AF-57-40
TECHNICAL ORDER
NO. 01-60J-45

22 February 1945

NORTH AMERICAN—INSPECTION AND REPLACEMENT OF COOLANT HEADER TANK INLET HOSE CLAMPS—P-51B, P-51C, P-51D, AND P-51K

This Technical Order replaces T. O. No. 01-60J-45, dated 16 January 1945, revised to list serial numbers of P-51K airplanes modified in production.

Figure 1 - Molded Ring and Retainers

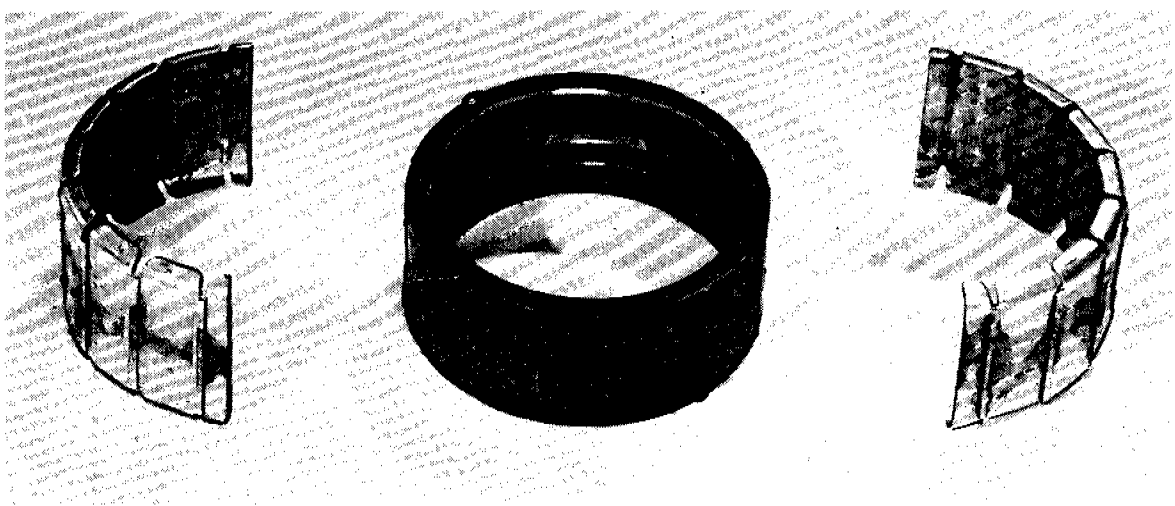
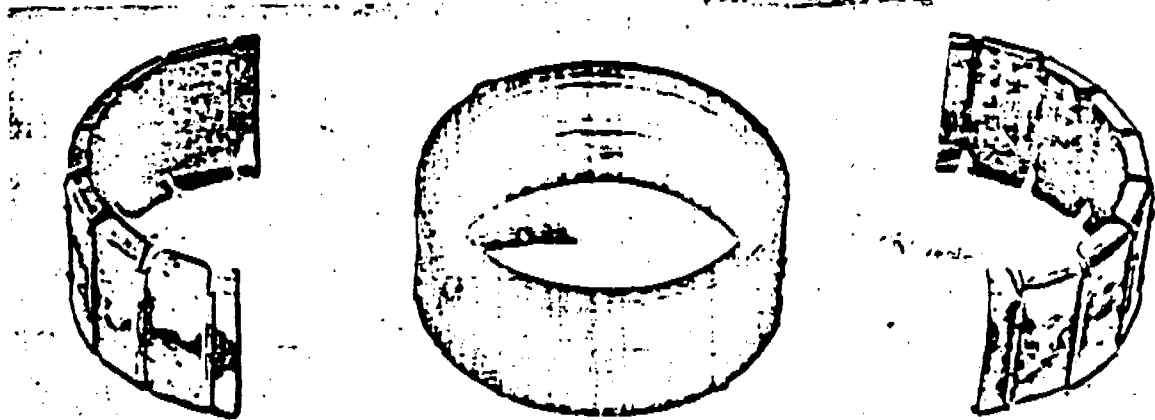
NOTE Retain neoprene ring, part No. 616478, and retainer, part No. 604867, for in-

stallation. (See figure 1.) Condemn all clamps used in this installation similar to those shown in figure 2.

Figure 4 - Complete
Assembly

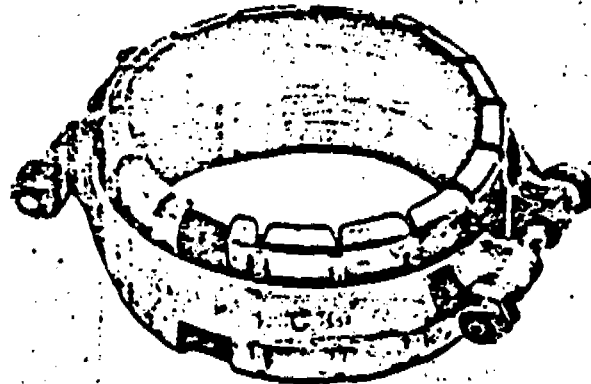
c. Install four clamps, North American, part No. 102-46086, or two clamps, Packard, part No. 606473, along with four bolts, part No. AN3-14A, and four nuts, part No. AN365-1032, unless already installed, over the retainers, part No. 604867, and molded neoprene ring and tighten the four bolts evenly. (See figure 4.)

NOTE Install retainers over molded neoprene ring leaving the extruded part of the ring between the ends of the retainers. Install clamp so that separation in clamp is 90 degrees to separation in the retainers. If clamps, North American, part No. 606473, is not available, local manufacture will be accomplished in accordance with figure 3.

Figure 3
Clamp As-
sembly -
Coolant En-
gine Outlet

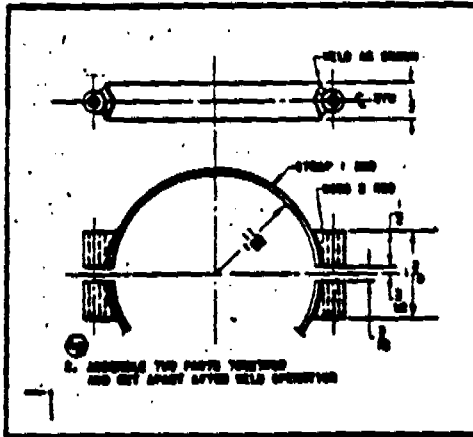
b. Inspect the coolant header tank inlet hose connections for clamps, North American, part No. 102-46086 (figure 3), and Packard, part No. 606473, removing any other clamps that may be installed.
